**C 2**  
**Communication**  
**Vaughan Metropolitan Centre**  
**Sub-Committee – March 26, 2025**  
**Item No. 1**

**RE: VMC Sub-Committee – March 26, 2025**  
**Item 4.1: VMC Secondary Plan Update**  
**Comments on behalf of the Portage Conversion Landowners Group**

## Re: MGP PLG VMC Vaughan Technical Memorandum

Figure 2: Proposed Site With Commerce Street Extension

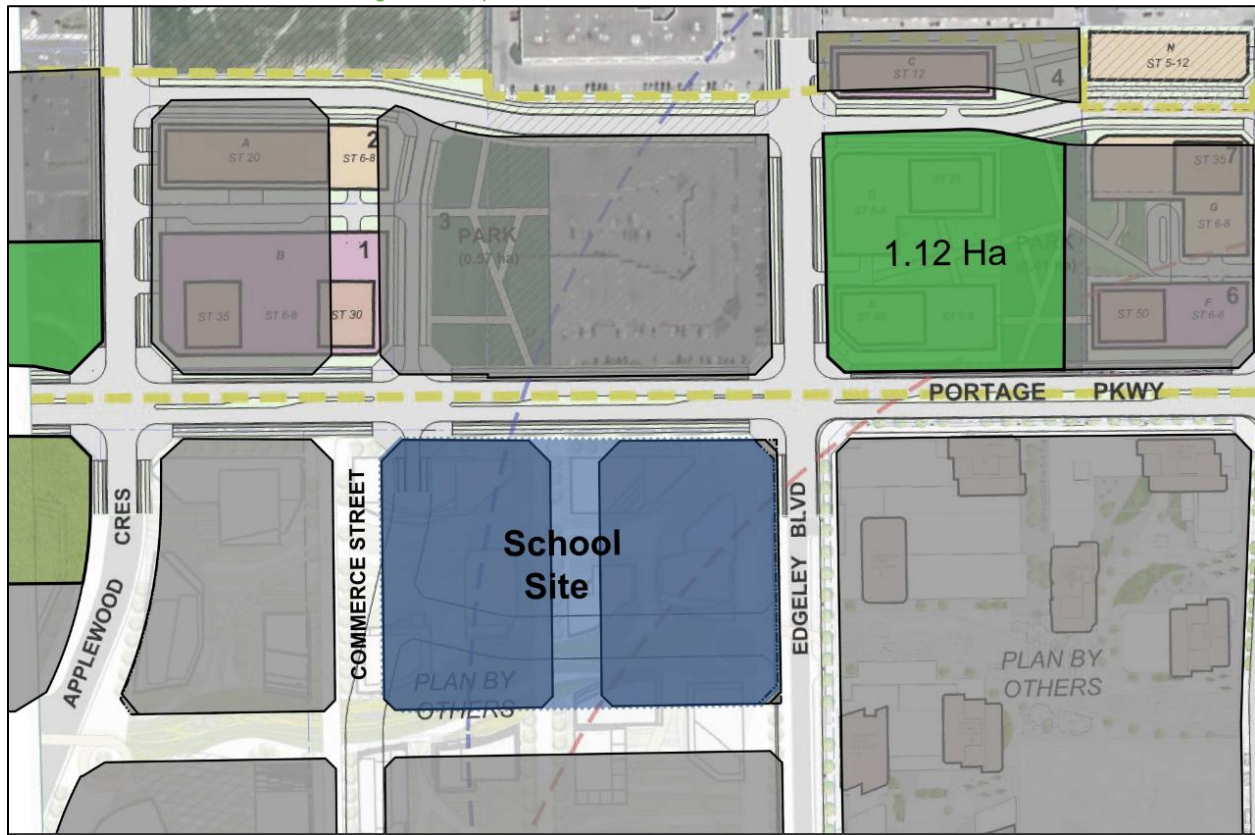
As Commerce Street is a local road, the main purpose is to provide access to land. The extension of Commerce Street from Portage Parkway to the new east-west street is not necessary to provide this function as the four surrounding streets provide sufficient access to the adjacent properties. Given the main purpose of a local road is for property access, and the adjacent properties on the north side of Portage Pkwy are already access from either Applewood Cres, Edgely Blvd, Portage Pkwy or the new east/west local street planned, a new local road (ie the extension of Commerce Street north of Portage Pkwy) is not warranted. Figure 2 illustrates the existing and planned roads in the site.

Furthermore, the extension of Commerce Street north of Portage Parkway would require a new signalized intersection in order to provide the connection north. The minimum intersection spacing for signalized controls is 200metres on collector roads as per TAC guidelines Chapter 2 (p.54). The Portage Parkway and Applewood Crescent intersection is a four-legged signalized intersection. The distance between the Portage Parkway and Applewood

Crescent intersection and the proposed Portage Parkway and Commerce Street intersection would be 136.4m measured centreline to centreline, thus not providing sufficient spacing between intersections.

There are many ways aside from local roads to provide connectivity, in this instance non-vehicular connectivity should be the primary focus. Mews, dedicated pathway, or Privately Owned Public Space (POPS) are options to allow pedestrian permeability through this block. A mews is a shared pathway that allow pedestrians and cyclists to travel on and access the land. A dedicated pathway would allow pedestrian and cyclists to travel on the pathway. A POPS would be owned by the final occupant of the site but be publicly accessible to allow pedestrians and cyclists to travel from Portage Parkway to the new east-west road. These alternative options allow for land access that the Commerce Street extension would have provided to pedestrian and cyclists while being able to avoid the concerns regarding the spacing of the intersections. However, we would recommend that such connectivity would be more appropriately located mid-block between Applewood Crescent and Edgely Boulevard.
